ADDENDUM #3

**PROJECT: BATON ROUGE POLICE DEPARTMENT TRAINING FACILITY
CITY PARISH PROJECT NO. 21-ASC-CP-1560**

ADDENDUM NUMBER THREE (3)

Project: **Baton Rouge Police Department
Training Facility**
999 West Irene Road
Zachary, Louisiana

3 EXTERIOR WALL BASE
 3" = 1'-0"

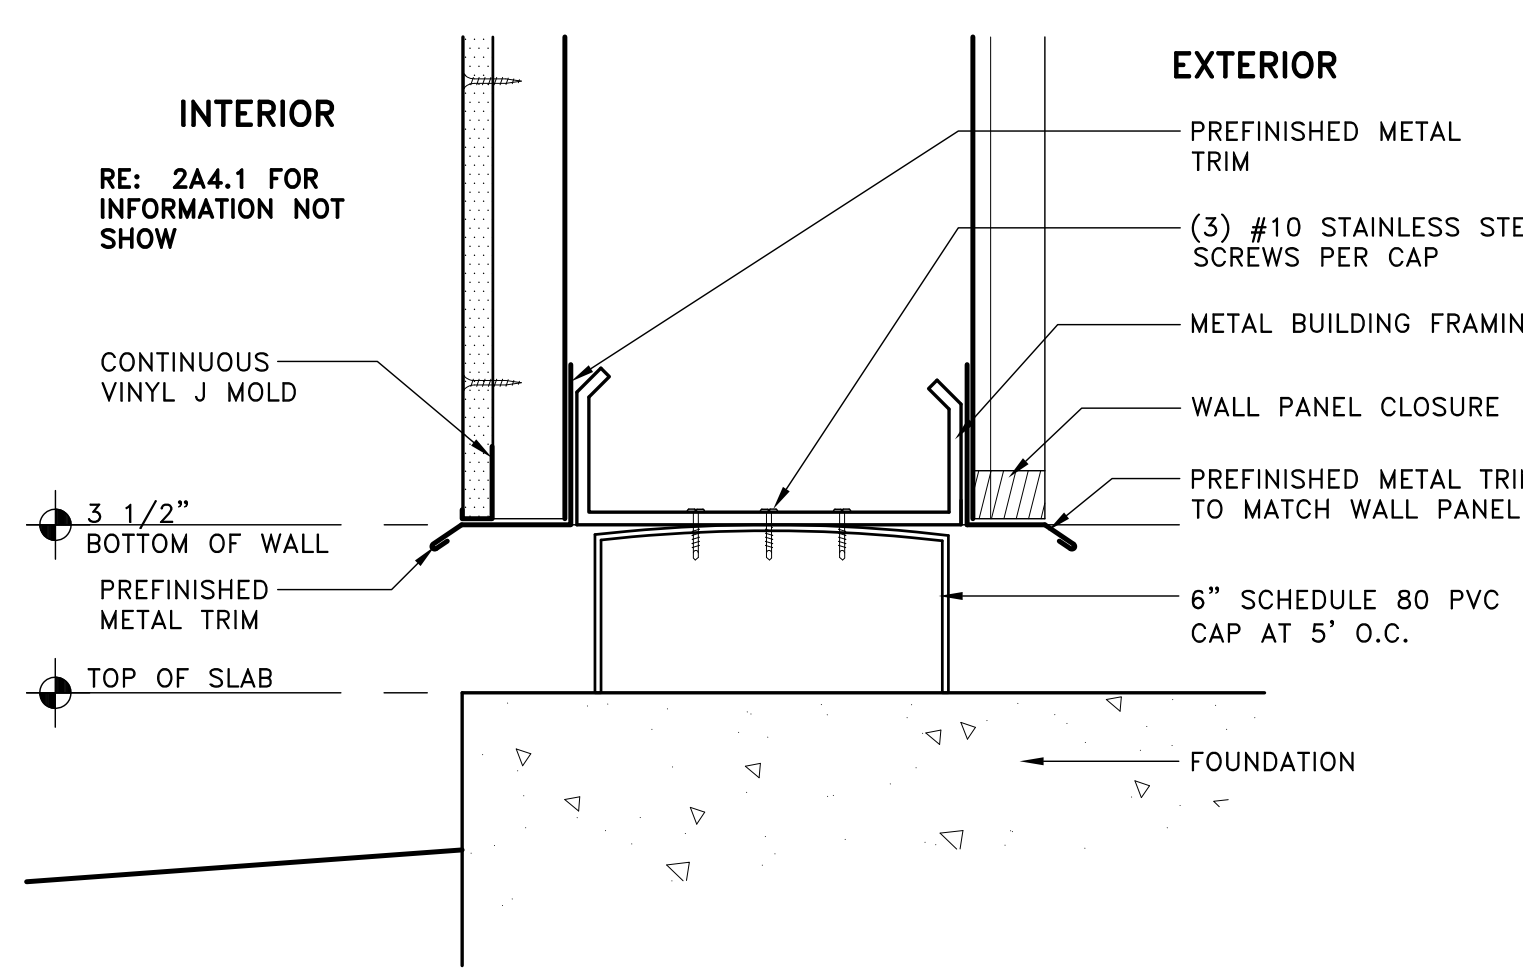
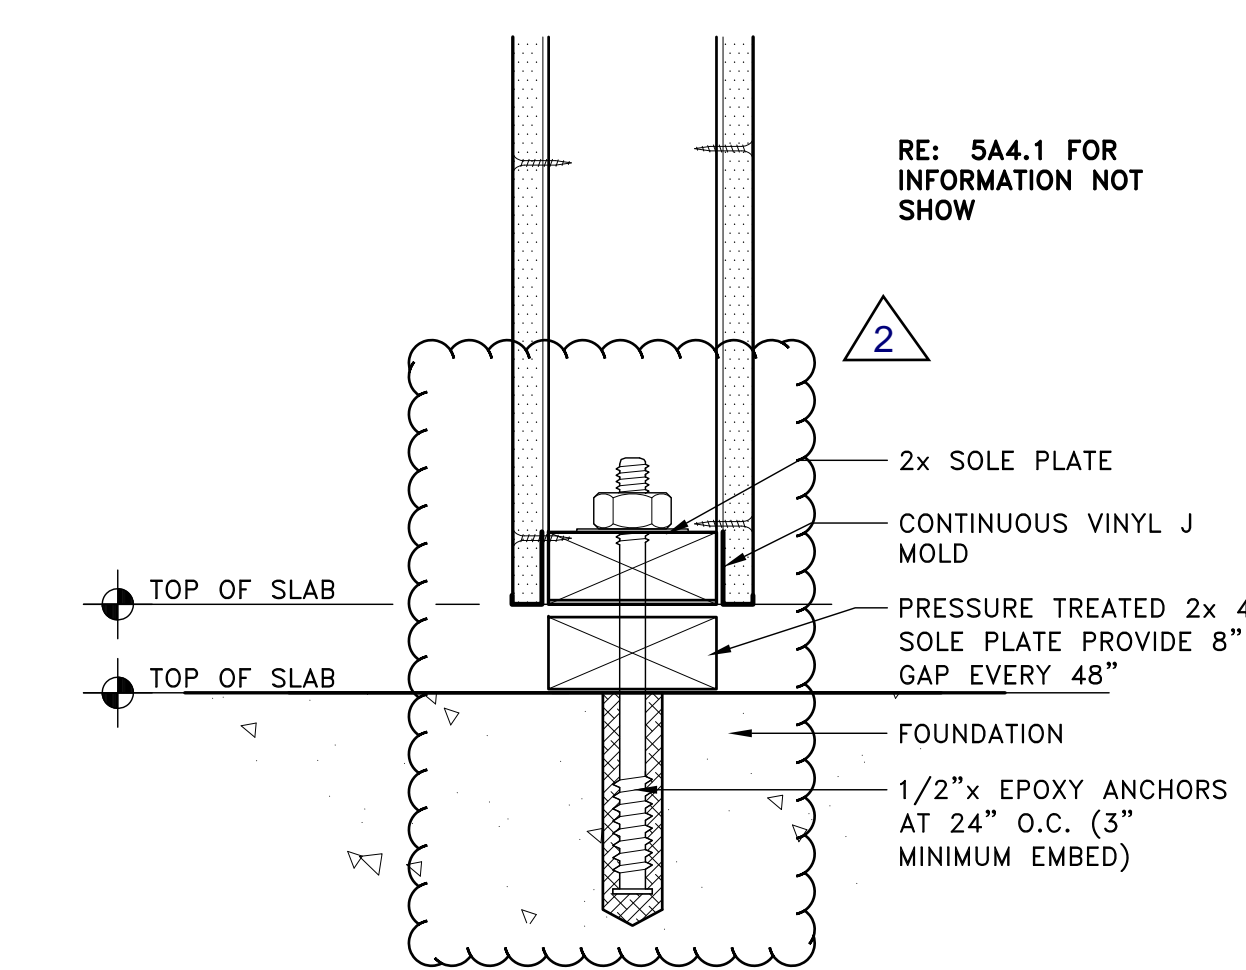
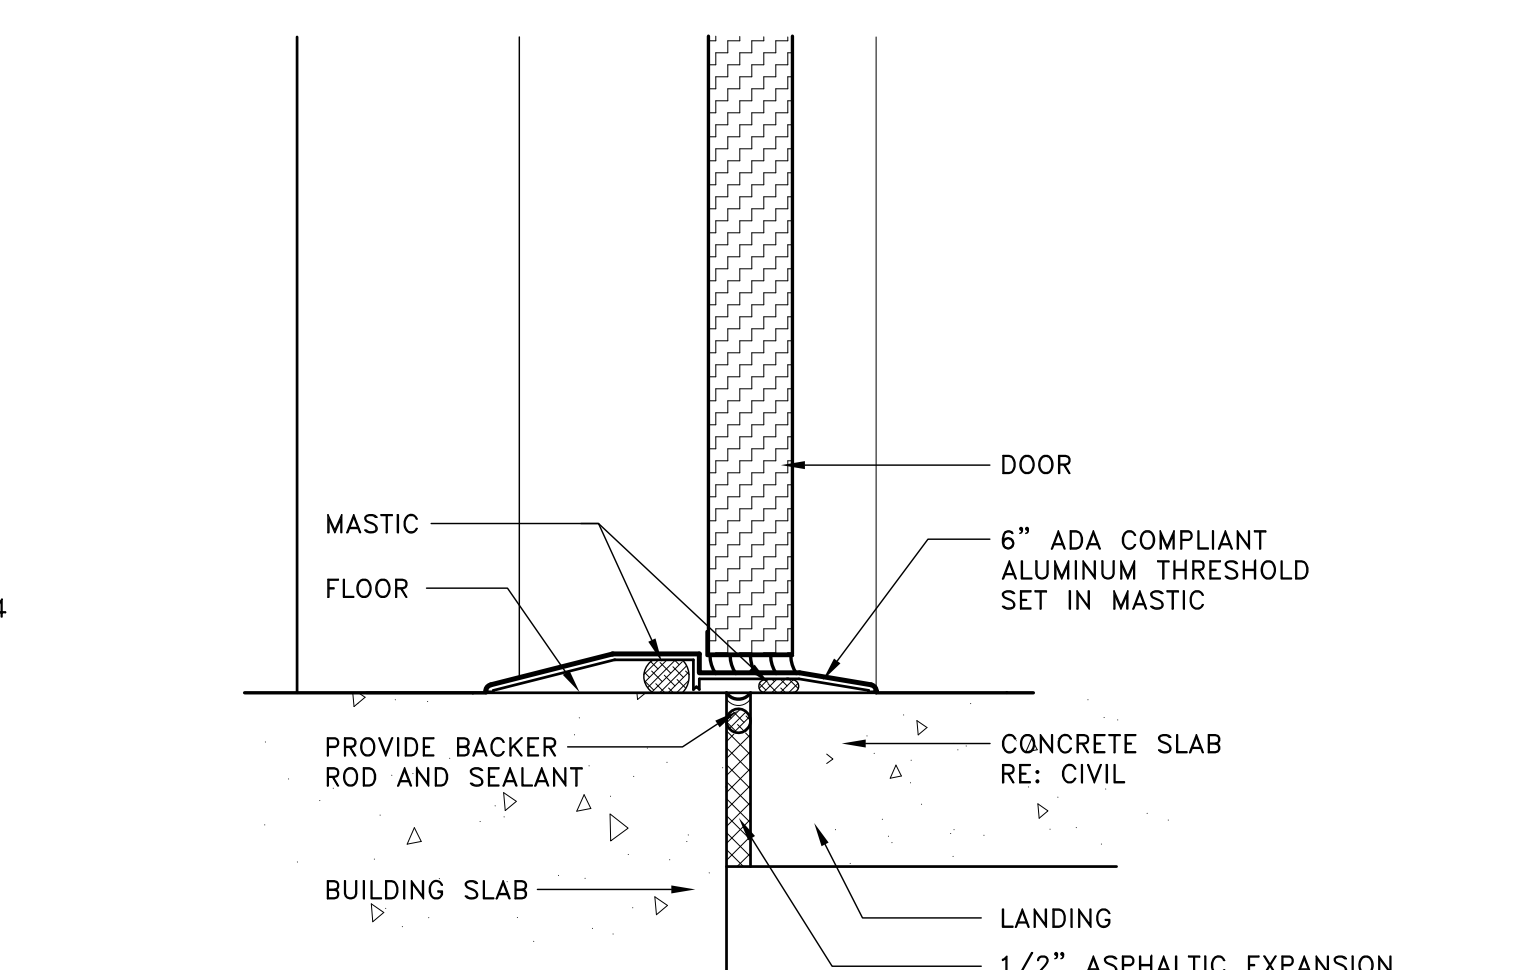
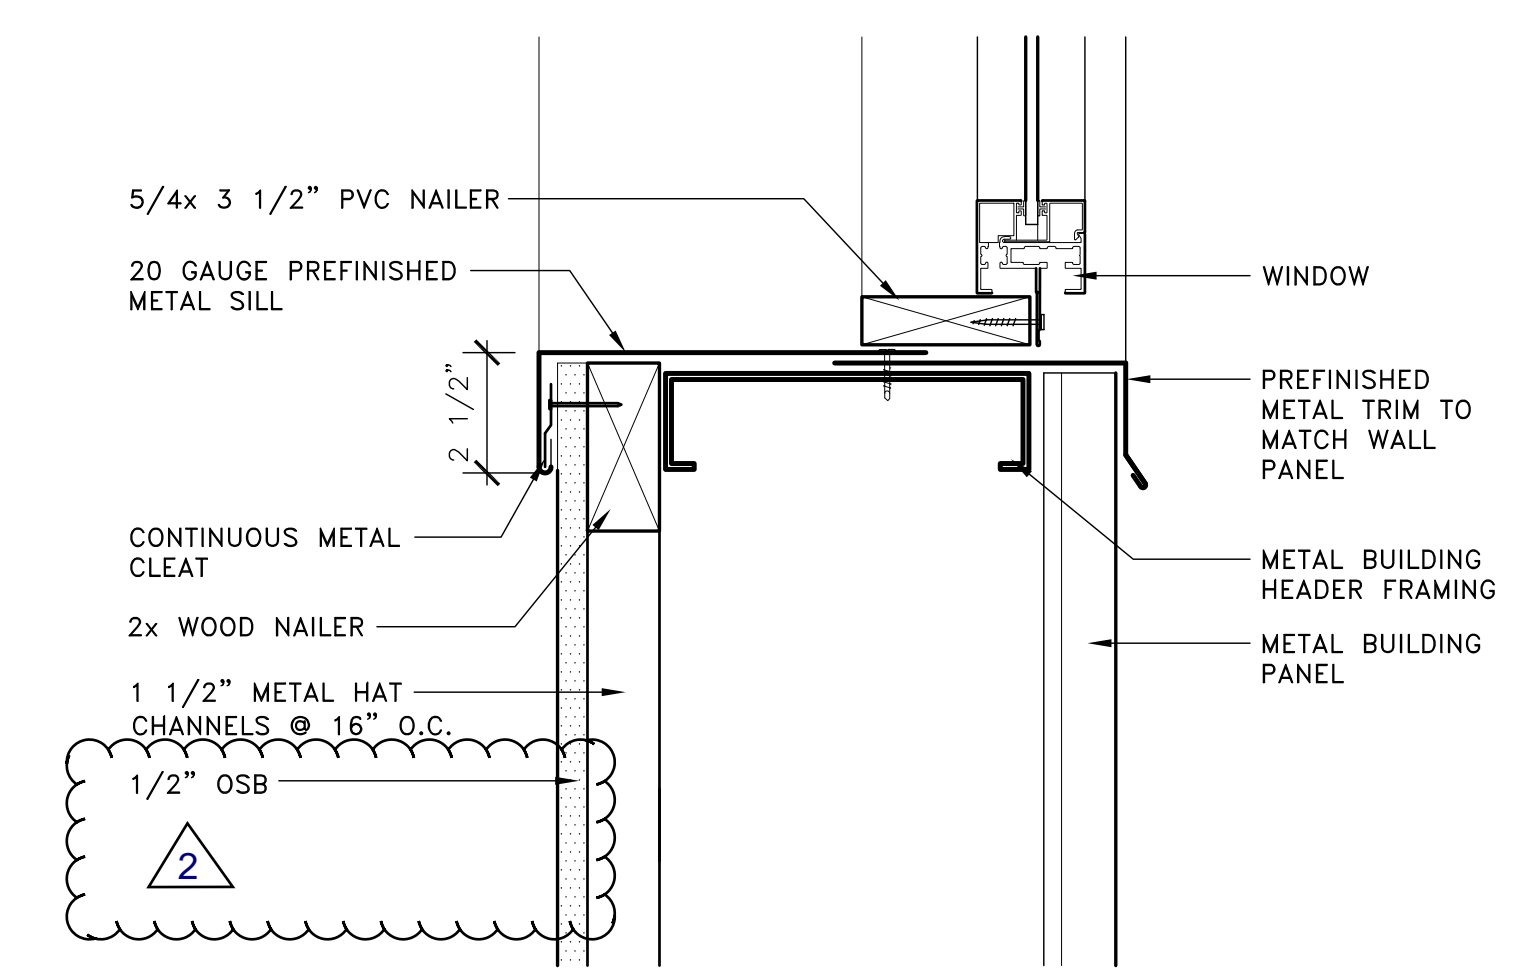
1. Delete existing sheet A4.1 and replace with new sheet A4.1 included in this addendum.
Changes include:
 - a. At interior walls, changed metal studs to 2x 4 wood
 - b. At interior walls, deleted metal wall cap in favor of painted 1x 6

- c. All interior walls changed gypsum board to OSB
